Steering Committee Meeting
April 23, 2021 3pm-4pm
ZOOM

Meeting Objective: Review San Bruno Avenue Master Plan Draft Diagrams with the San Bruno Avenue neighbors for input, noting that this is mostly about parking, sidewalks and curbs. Landscape solutions come later.

Concept Diagram Draft
Potrero Loop Phase II: San Bruno Master Plan
Option #1
SFPW- Landscape Architecture
Draft 4/21/2021

Concept Diagram Draft
 Potrero Loop Phase II: San Bruno Master Plan
 Option #3
 SFPW- Landscape Architecture
 Draft 4/21/2021

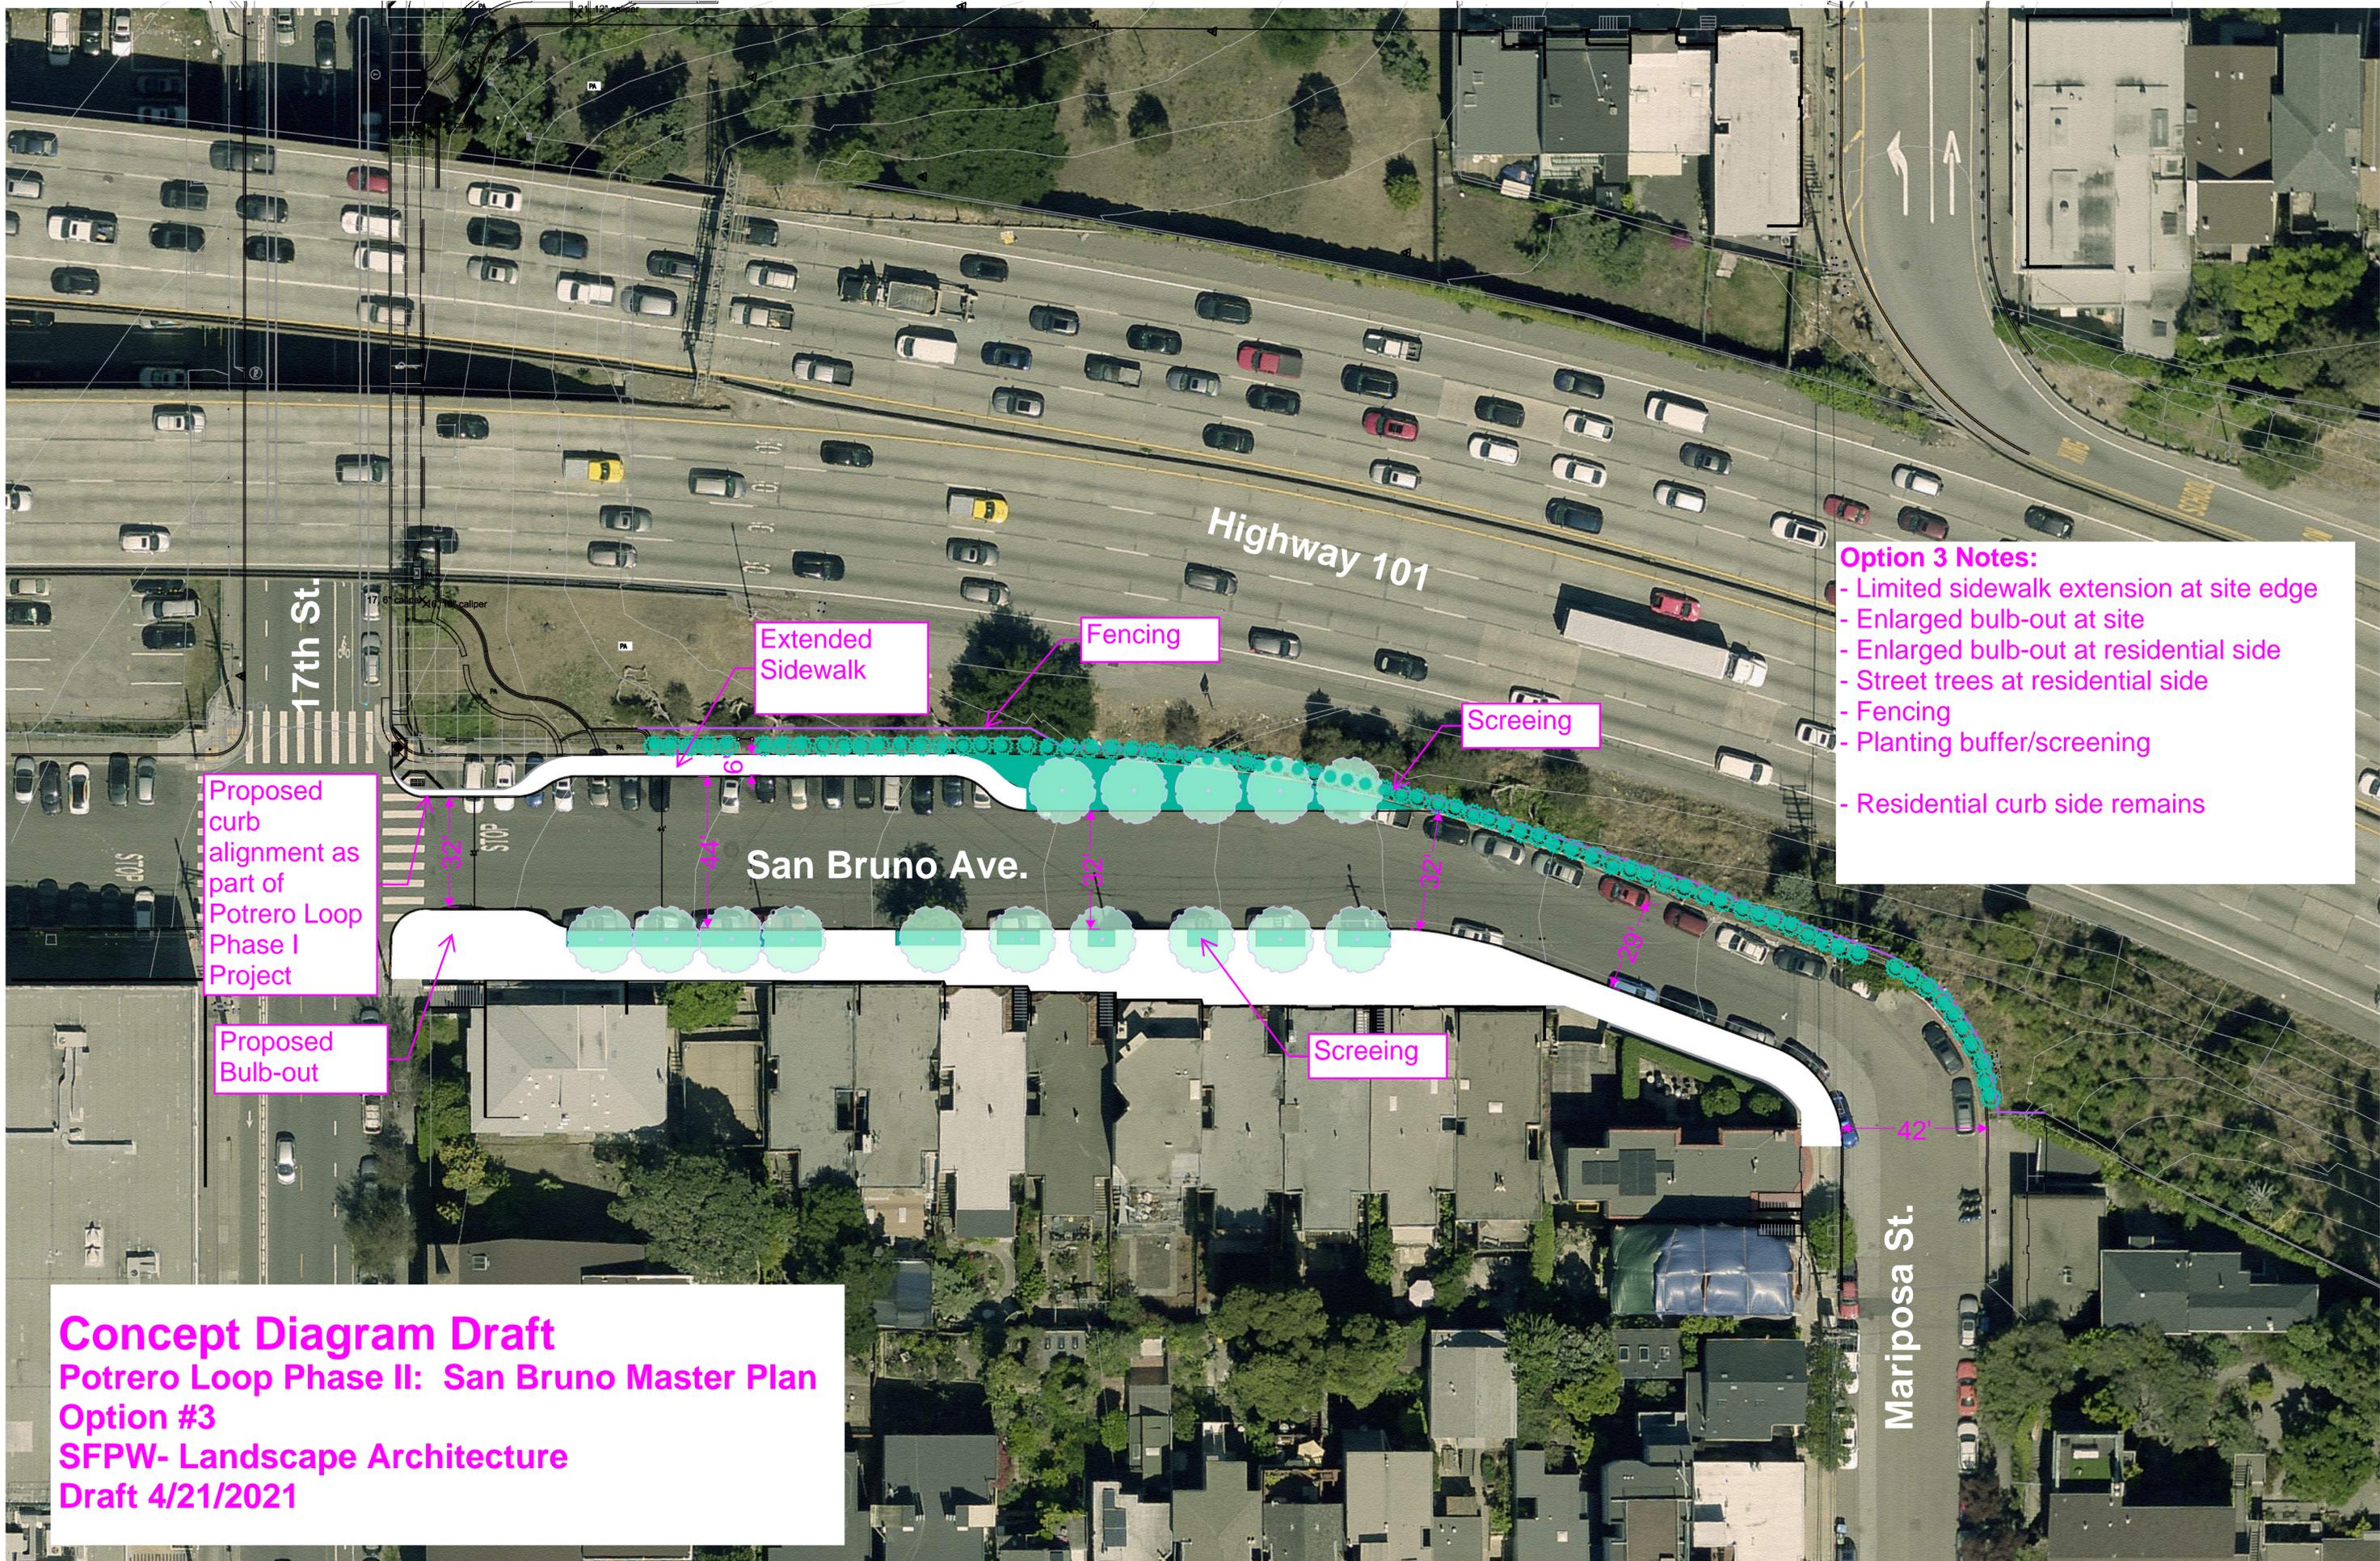
Option 3 included the idea of street trees. It was noted that this was something the GBD could work on. It also included a bulbout on the west side of Vermont which would remove marking, which may be a negative. The new plaza/greening area could possibly include raised gardens or boulders to prevent camping. It also could be an area for a green wall experiment. Mary asked if vines could be grown on any fencing that replaces the chain-link. Jasmine noted that maintenance would have to be done by GBD or neighbors. Some version of Caltrans fence would be installed which is stringer than the existing chainlink.
